SUBJECT: A. M20K, LANDING LIGHT LENS RETROFIT TO ALLOW COOLING AIR TO CIRCULATE THROUGH CAVITY.
B. ADDITION OF SHIELD TO EXHAUST SYSTEM TO DISSIPATE HEAT.

MODELS/ S/N AFFECTED: Part A: M20K S/N 25-0001 thru 25-TBA (Mooney 231 & 252)
Part B: M20K S/N 25-1000 thru 25-TBA (Mooney 252)

SERVICE BULLETIN: M20-235
 DATE: 2-20-87

FIGURE SB M235-1

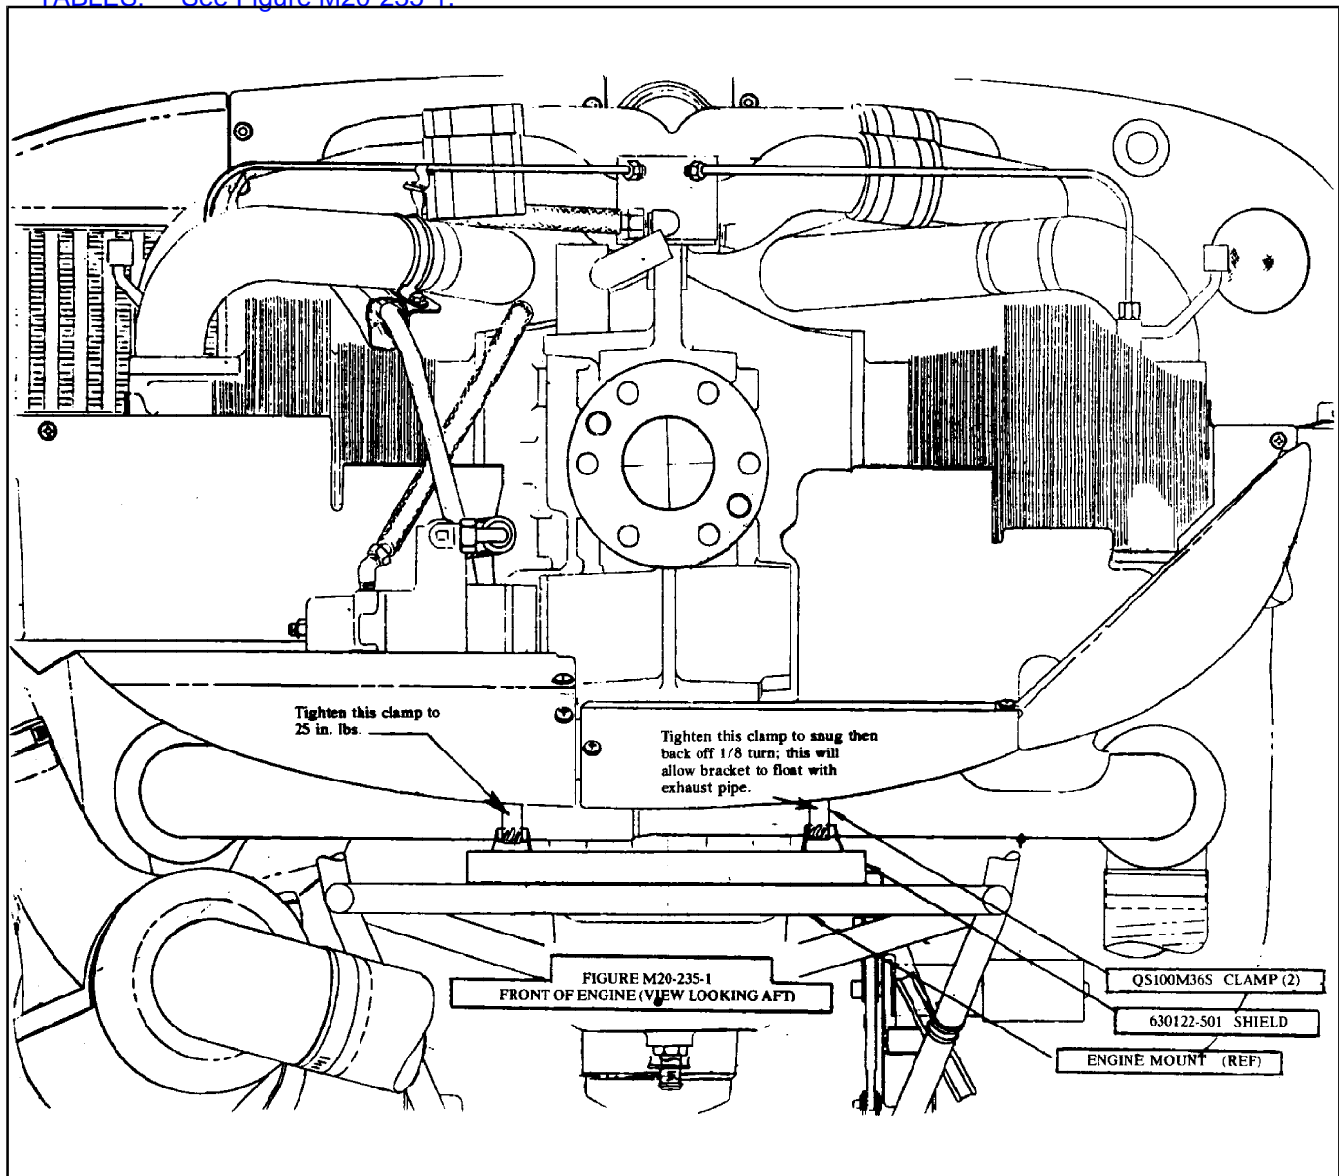
8. Install exhaust shield assy, P/N 630122-501 using (2 ea.) P/N QS100M36S clamps to secure on engine exhaust cross-over manifold, (see Figure No. M20-235-1).
